**MONTGOMERY COUNTY PLANNING DEPARTMENT**  
THE MARYLAND-NATIONAL CAPITAL PARK AND PLANNING COMMISSION

**PLAN NAME:** Brookside Gardens Parking Renovation

**PLAN NUMBER:** FCP #PP1995001

**REVIEW TYPE:** Revised Preliminary Forest Conservation Plan (PFCP) Review

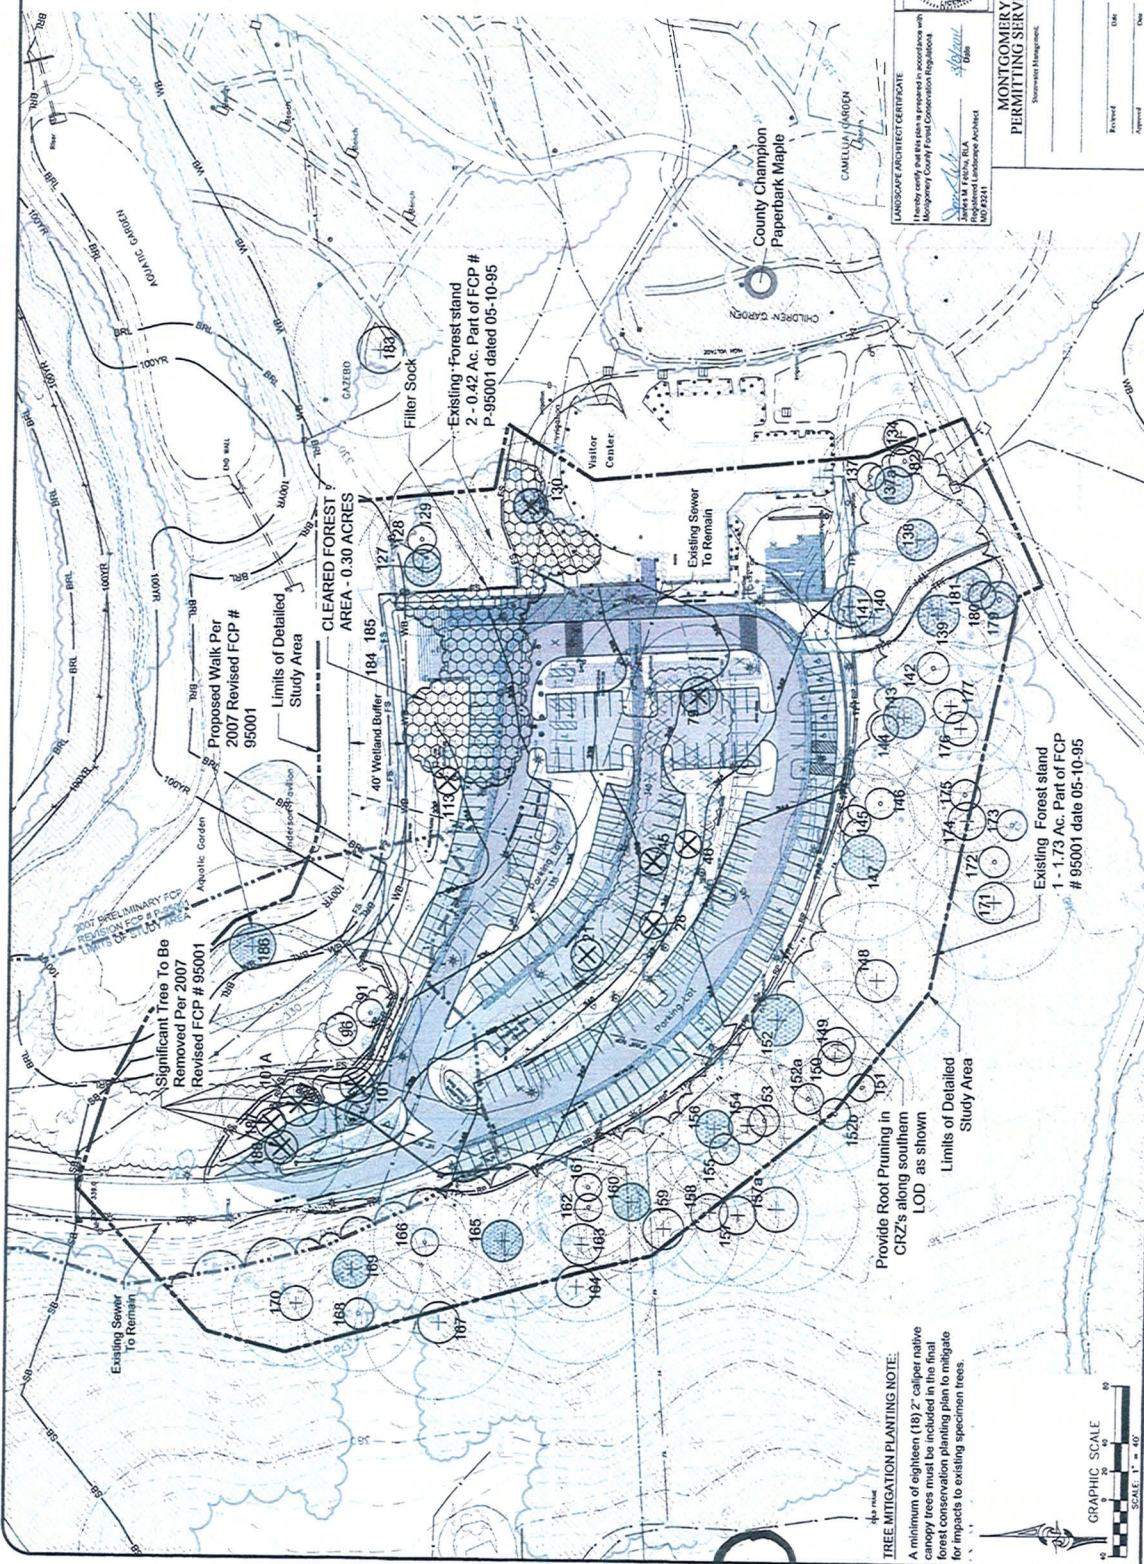
**Abbrev. Tree Stem Recommendation Note:**  
For all important trees with CRZ of 10 or more impacted by the proposed LOD located on the site, the following tree stem recommendations shall be followed for protection and preservation. Above grade pruning practices shall be used to protect and preserve for such trees. Root pruning practices shall be used to protect and preserve for such trees. All trees to be removed shall be removed in a timely manner. In addition, see the note in the plan for all trees along the southern edge of LOD.
